TECHNICAL BULLETIN 014

24/04/2006

FIAT 1.6 PETROL ENGINES / SYNCHRONOUS DRIVE / TENSIONER INFO

FIG. 4

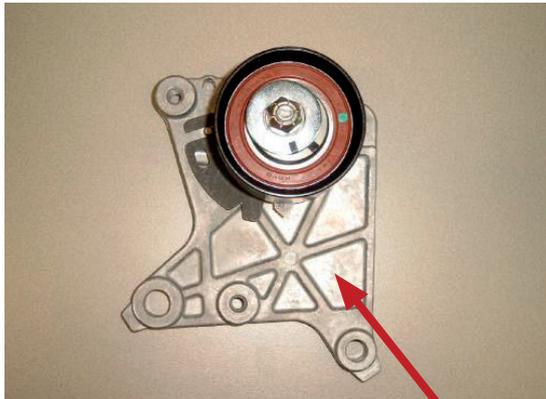
Fig. 4 and Fig. 5 show the latest version of the tensioner fixed on the bracket.

Normally this bracket (C) is mounted on the engine block and does not have to be removed.

FIG. 5

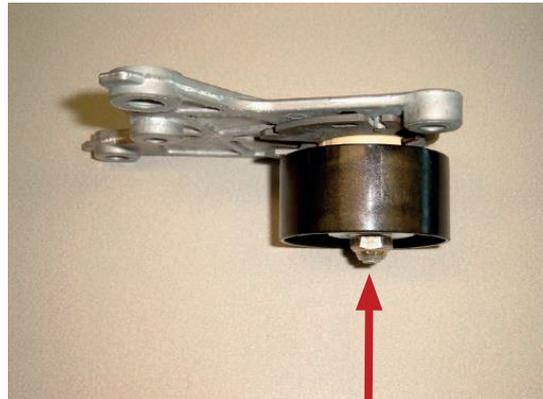
The latest version that is now used on OE(S) level replaces the two previous parts. It may be possible that the tensioner on the car is still an older model. There is no problem to install the latest version tensioner with the old stud and nut. Although the depth of the fixing hole (A) of the tensioner is deeper and the stud stays the same, there is still enough room on the stud to fix the nut properly, see Fig. 5 (B).

FIG. 8

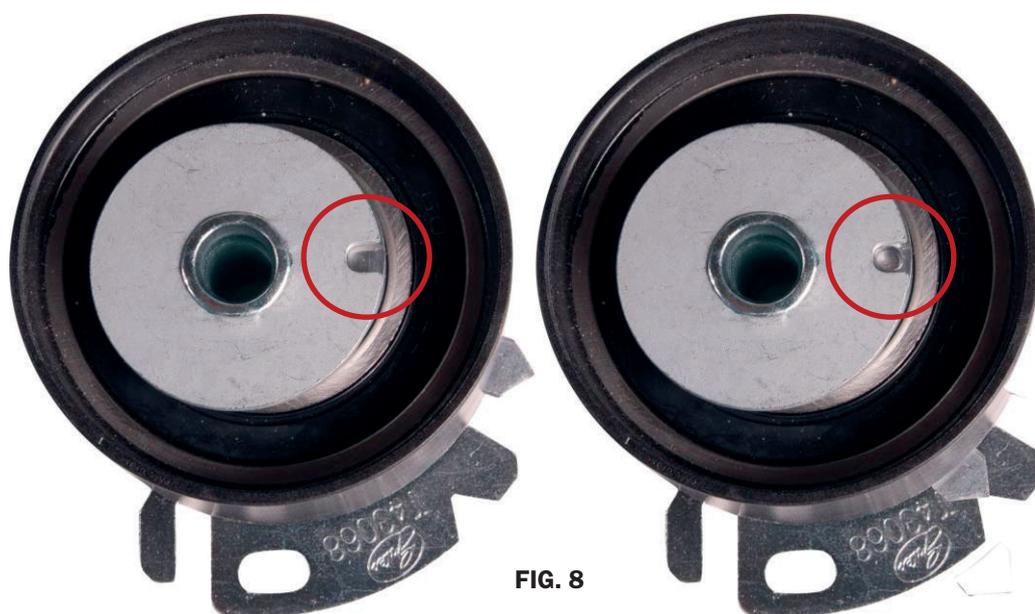
In the actual kits you find the tensioner (Fig. 8) on which we have changed the black marks into a new positioning system. The indicator of the correct position is a point in relief.

Not in the correct position:

In the correct position:
